# TECHNICAL SERVICE BULLETIN

## 10R80 - Harsh/Delayed Engagement And/Or Harsh/Delayed Shift

**23-2123**

<b>Ford</b>
2018-2021 Expedition
2017-2020 F-150
2018-2021 Mustang
2019-2023 Ranger
<b>Lincoln</b>
2018-2021 Navigator

Figure 1 - Example of a normal amount of metal flakes on the transmission fluid pan magnet

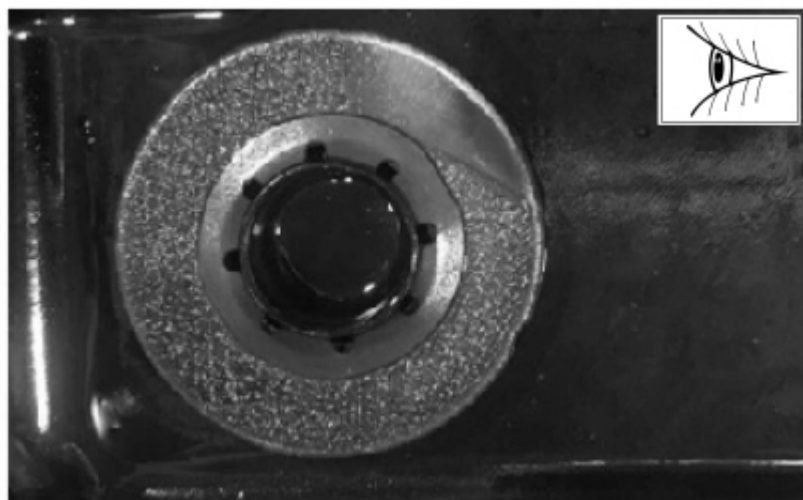
- Upon removal of the transmission fluid pan, metal flakes may be present on the magnet. This is a normal condition. (Figure 1)
